REMARKS

Applicant cancelled claim 131, amended claims 7, 9, 33, 102, 106, 130, 132, and 147, and added new claims 156-174 to further define Applicant's claimed invention. The amendment to claim 102 is supported by claim 131 as originally filed. New claims 156-165 are supported at least by claims 7, 14, 15, 21, 22, 34, 38, and 40-42, respectively, as originally filed. New claims 166, 169, and 172 are supported by the specification at least on page 16, lines 4-6 and Figs. 4, 5, and 9. New claims 167, 168, 170, 171, 173, and 174 are supported at least by Figs. 4, 5, and 9. New claims 157, 158, 161-163, and 166-174 read on the invention of Group I, Species 1, Fig. 5. Applicant submits that the subject matter of new claims 156, 159, 160, 164, and 165 was not identified by the Examiner as being a separate, patentably distinct species and is therefore not subject to the Examiner's Restriction Requirement of November 30, 2001. Applicant submits that claims 156-174, dependent from one of independent claims 1, 102, and 147, or claims dependent therefrom, are patentable at least due to their dependency from an allowable independent claim.

FIG. 9B

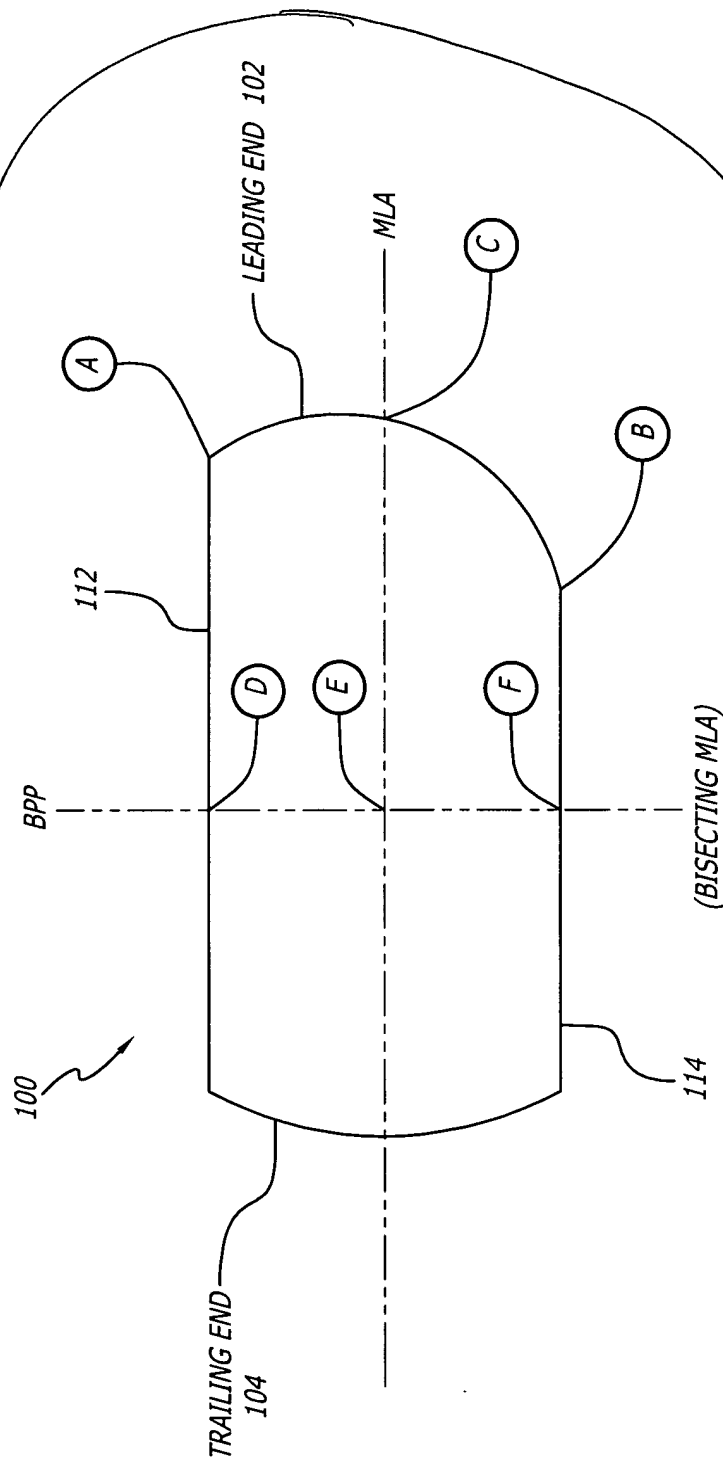
The Examiner objected to the drawings under 37 C.F.R. § 1.83(a) for not showing every feature of the claimed invention. In particular, the Examiner contends that the features "facing side walls," "inner surfaces facing each other," "hollow interior," and "first distance greater than the third" are not shown. Applicant respectfully traverses the Examiner's objection relative to the feature of "facing side walls." Fig. 9A (previously Fig. 9) shows an interior facing side wall 112 and an exterior facing side wall 114. (See, e.g., Specification, page 16, lines 15-17). For the other features noted by the Examiner, Applicant is submitting concurrently herewith a proposed drawing correction with new Figs. 6B and 9B. Fig. 6B is a cross section of Fig. 5 showing the side walls having an inner surface facing each other. Fig. 6B also shows the hollow interior of implant 100. Fig. 9B shows an implant where the first distance C is greater than the third distance A.

New Fig. 6B is supported by the language of claim 35 as originally filed, page 16, line 20 of the specification, and Fig. 5. New Fig. 9B is supported by the language of claim 2 as originally filed and page 17, lines 16-19 of the specification. No new matter has been added.

FIG. 5

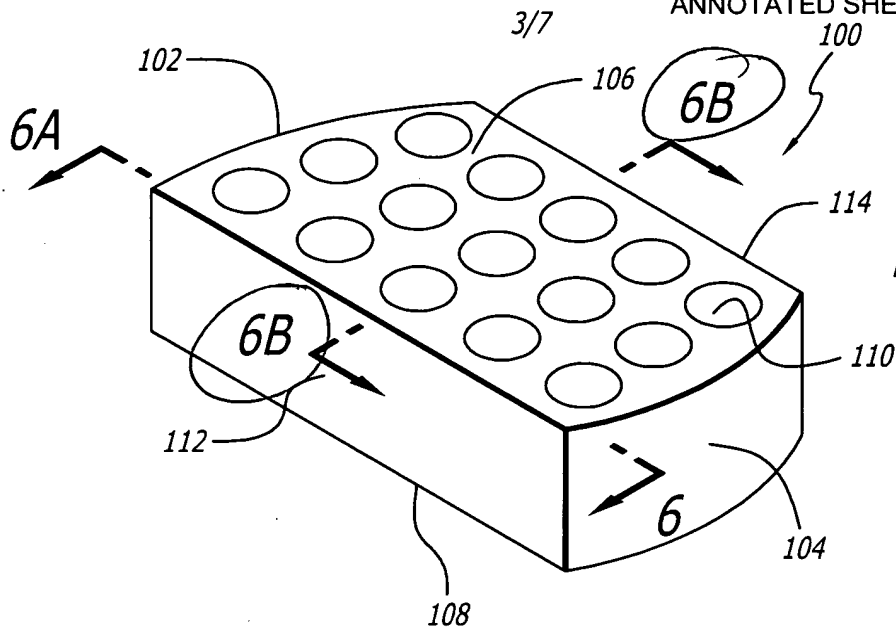
The Examiner contends that Figs. 5 and 6 show the implant to be solid between the openings. (Office Action, page 4, first paragraph). Applicant respectfully traverses the Examiner's contention. Fig. 6 shows a cross section of implant 100 taken through the thickness of the side wall between the top edge of side wall 112 and the leftmost column of openings 110. (See, e.g., Fig. 5). Fig. 6 shows the side wall of the implant with cross hatching to illustrate that the implant is made of an artificial material. (See specification, page 13, lines 8-18). Contrary to the Examiner's contention, Fig. 6 does not show that "the implant is solid between the openings" because as shown in Fig. 5, line 6--6 does not run between any of the openings.

FIG. 6B

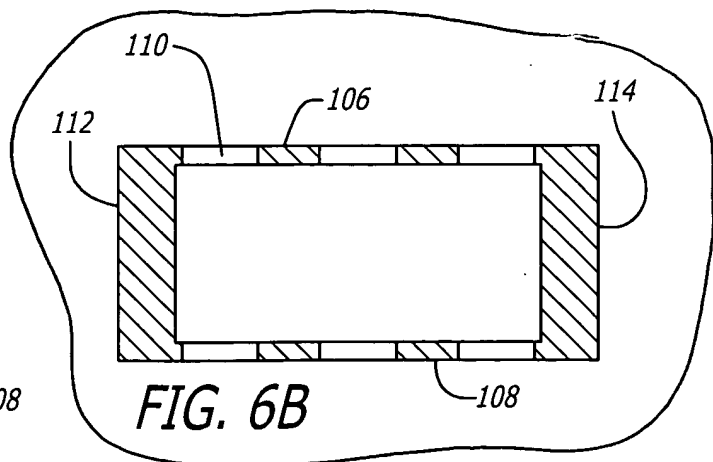
The Examiner rejected claims 1, 8, 9, 39, and 102-155 under 35 U.S.C. § 112, second paragraph, as being indefinite for failing to particularly point out and distinctly claim the subject matter which Applicant regards as the invention. For the Examiner's rejection of claim 1, a marked-up copy of Fig. 6B showing the features relating to the claim recitations not understood by the Examiner is attached hereto as Exhibit A. Applicant notes that independent claim 1 is the only independent claim reciting the

dimensional limitation not understood by the Examiner. As stated in the specification, the interior facing side wall is the portion of the implant adapted to be placed toward another implant when the implant is inserted in pairs into the disc space. (See Specification, page 16, lines 17-19). The recitations of claim 1 relating to the maximum dimension of the hollow interior and the maximum dimension of the opening are shown and labeled for the Examiner's convenience in Exhibit A.
